Technical BULLETIN

SAFETY RECALL

CERTAIN 2017~2023 GATOR TOUGH 16 DK BOATS FACTORY MODIFICATION CAMPAIGN – Port Level Flotation Compliance

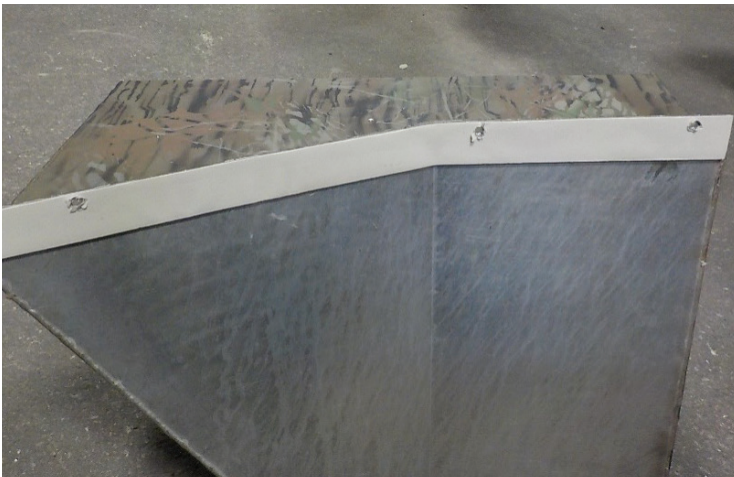
1. Remove the decals from both sides of the back of the boat.

2. Remove the white protective covering from the adhesive side of the foam tape supplied in the kit and apply it to the buoyancy pods.

3. Drill 3 holes in the angle tab on each side of the transom using a #11 drill bit as shown. Remove the white protective covering from the adhesive side of the tape supplied in the kit and apply it to the angle tabs.

4. Drill three 1/4" holes in each pod in the top lip as shown.
